ADDENDUM

ADDENDUM No. 3	GMCa JOB #: 202113 TDH
ISSUE DATE: 04.22.24	SBC #: 364/011-05-2021
PROJECT: Tennessee Tech University Derryberry Hall – Building Upgrades – Phase I	1 William L. Jones Drive Cookeville, TN 38505
OWNER: Tennessee Tech University	1 Bridgestone Park, 3 rd Floor Nashville, TN 37214
ARCHITECT: Gilbert McLaughlin Casella architects	2305 Kline Ave, Suite 200 Nashville, TN 37211

ELECTRICAL POWER & SYSTEMS PLAN LEVEL 2

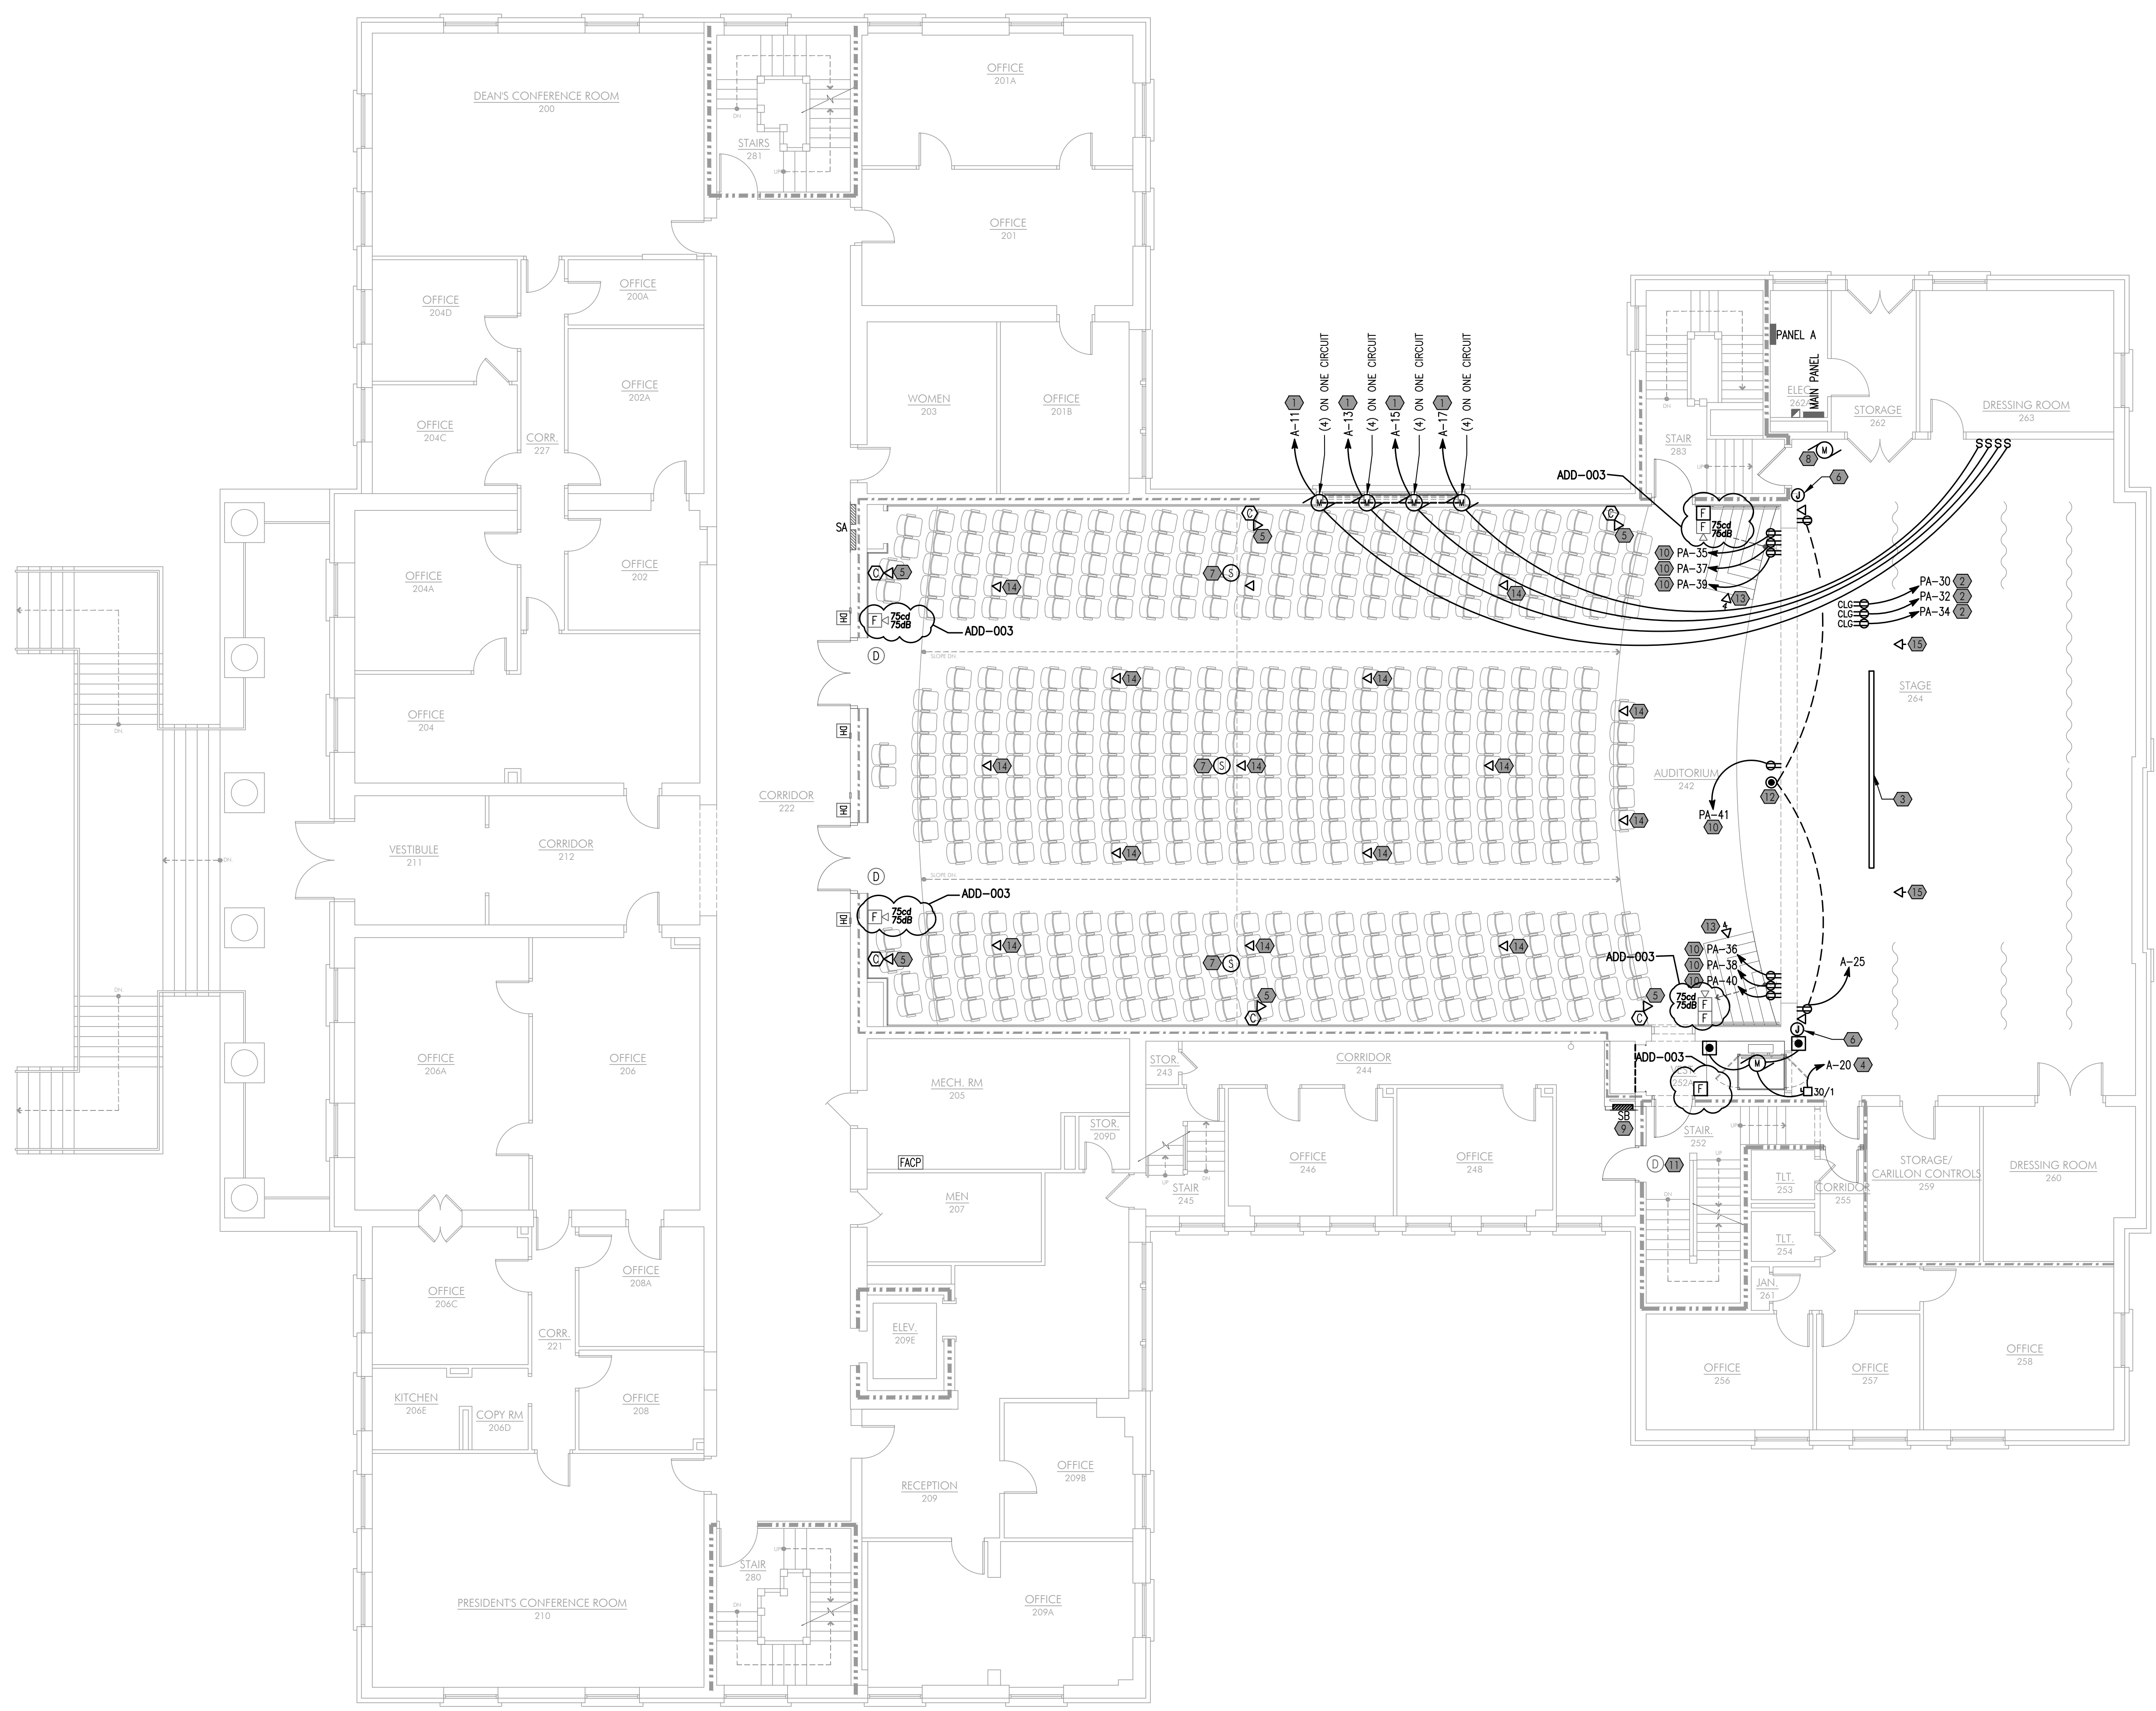
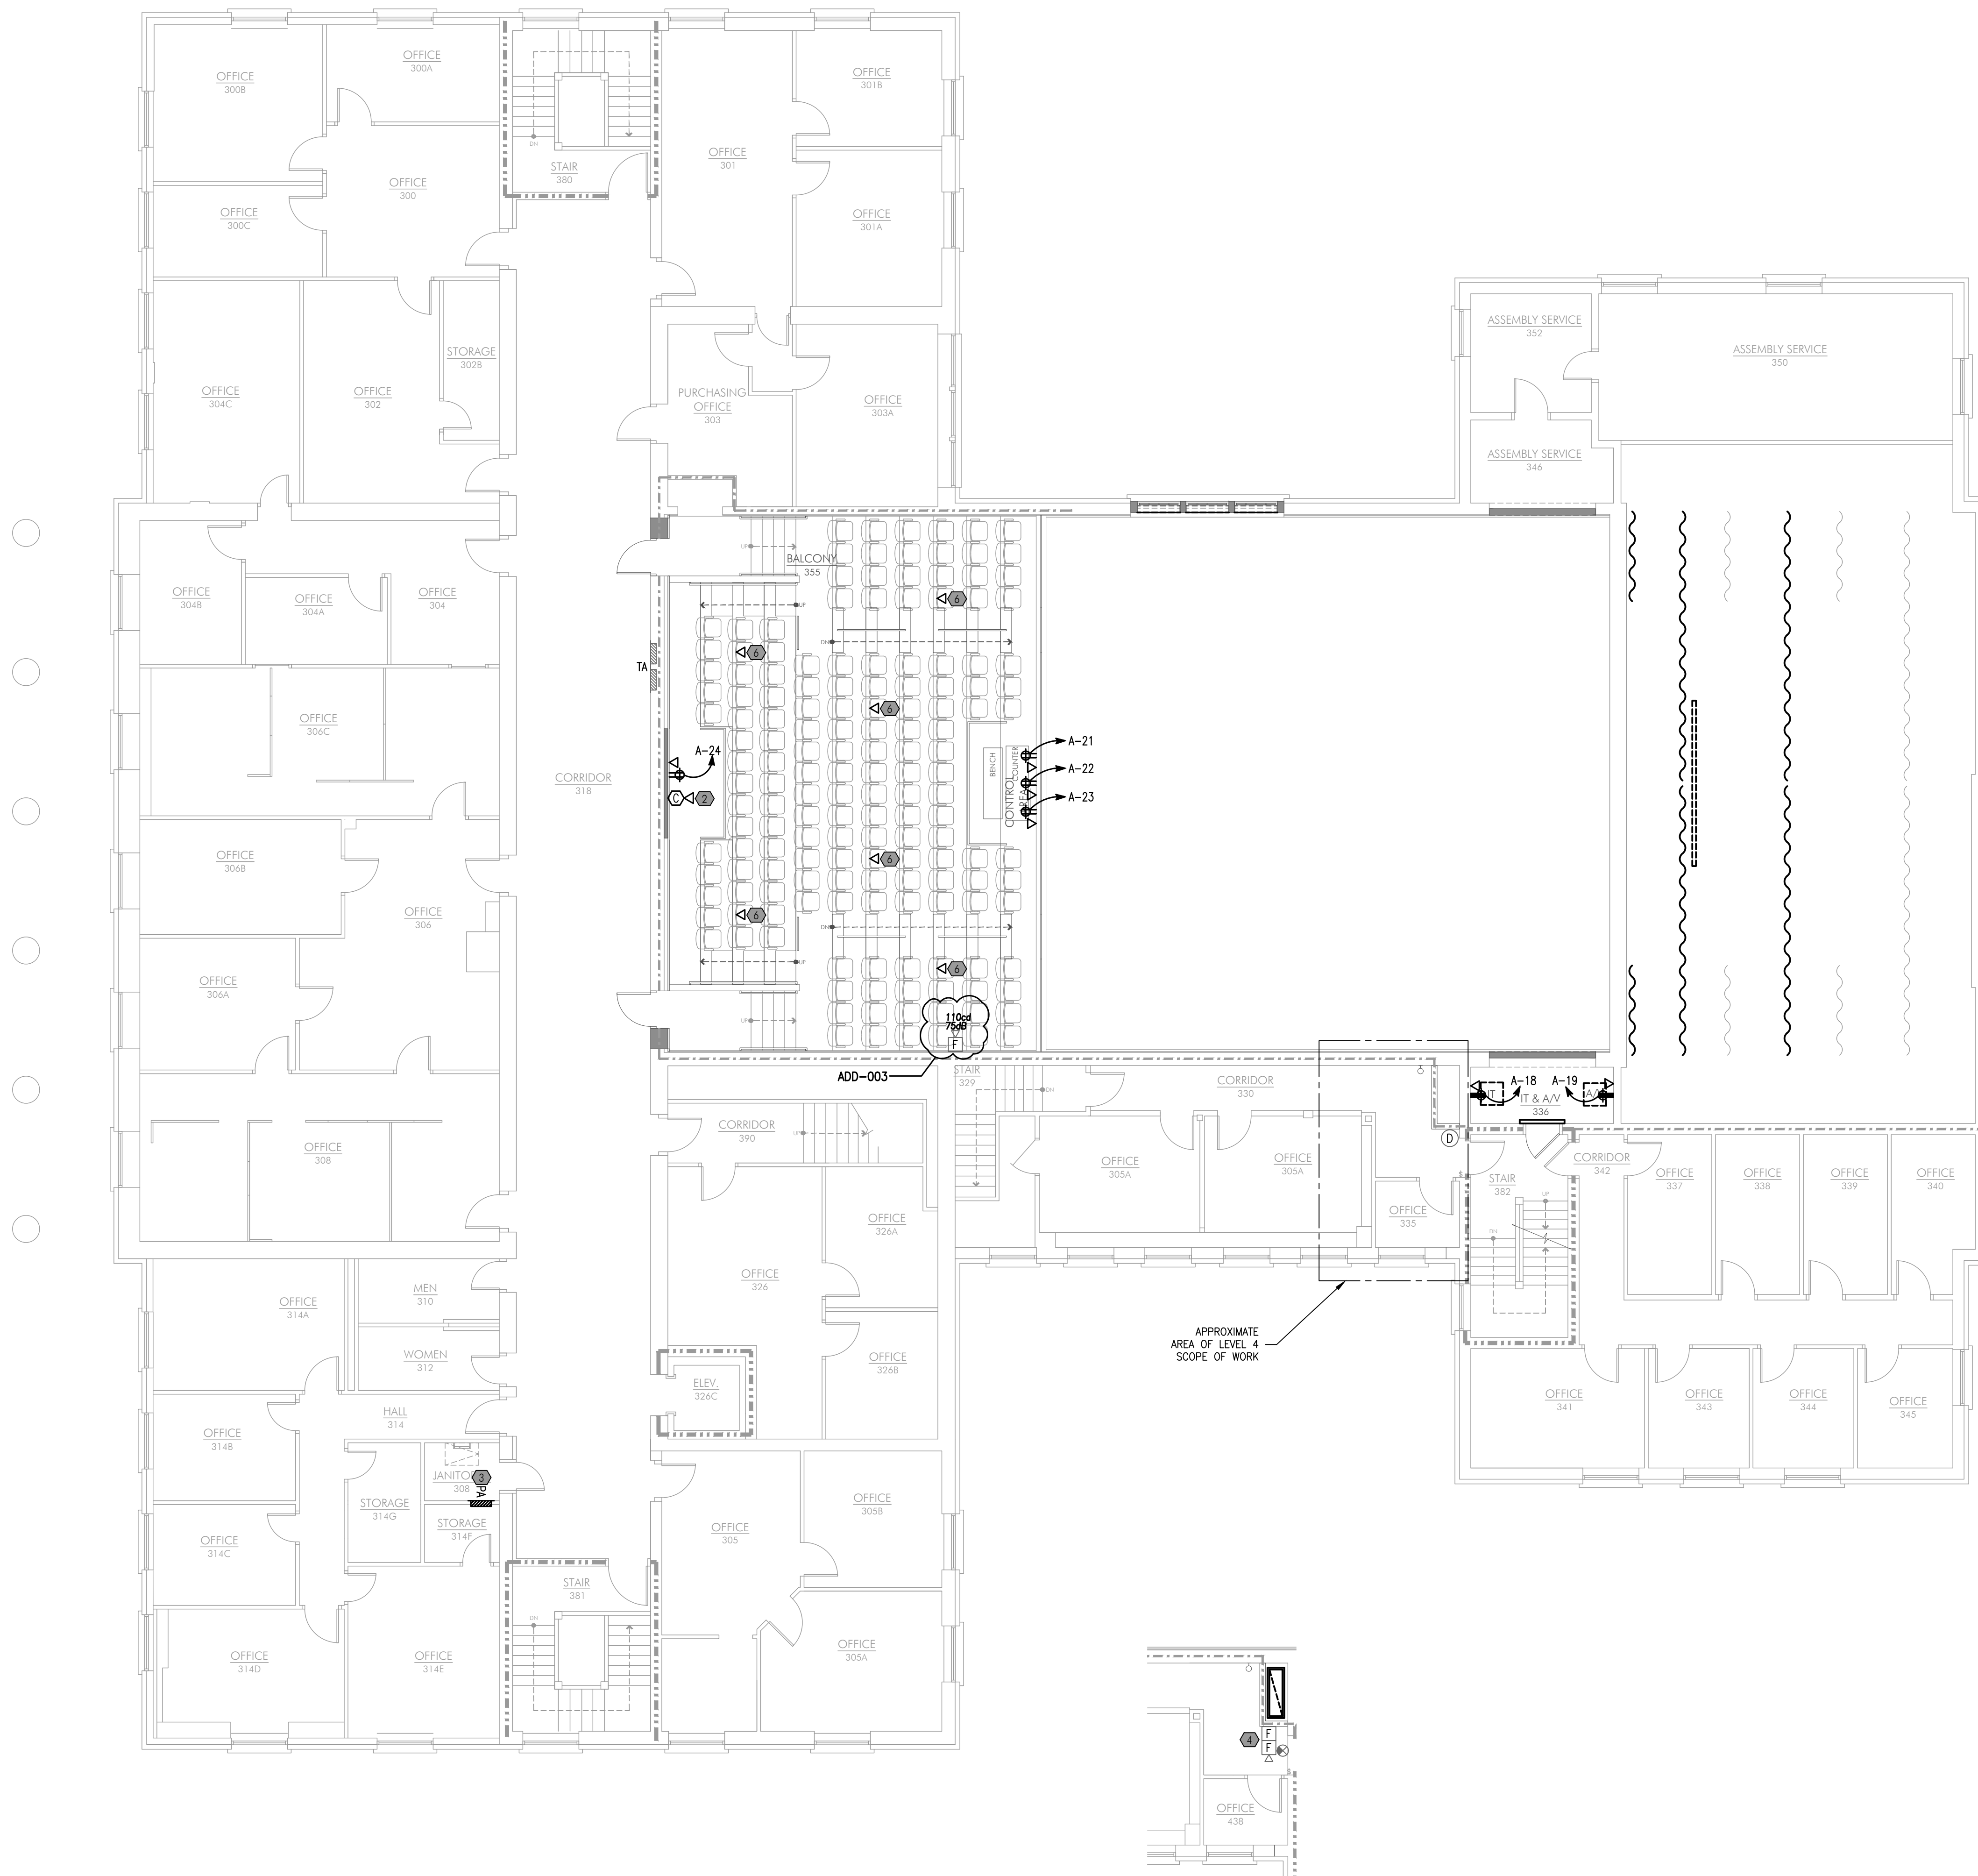
- a) **Per SFM Comments:** Provided Fire Alarm Pull Stations at Auditorium-242 door into Stair-283 and Vestibule-252A door into Stair-252
 - b) **Per SFM Comments:** Added decibel ratings to all audible notification devices and candela ratings to all visible notification devices.

- c) Updated General Note E to call out pull-wire and conduit routing.
- 7) E3.3 - Electrical Power & Systems Plan - Level 3
 - a) **Per SFM Comments:** Added General Note E to call out required duration of emergency power systems.
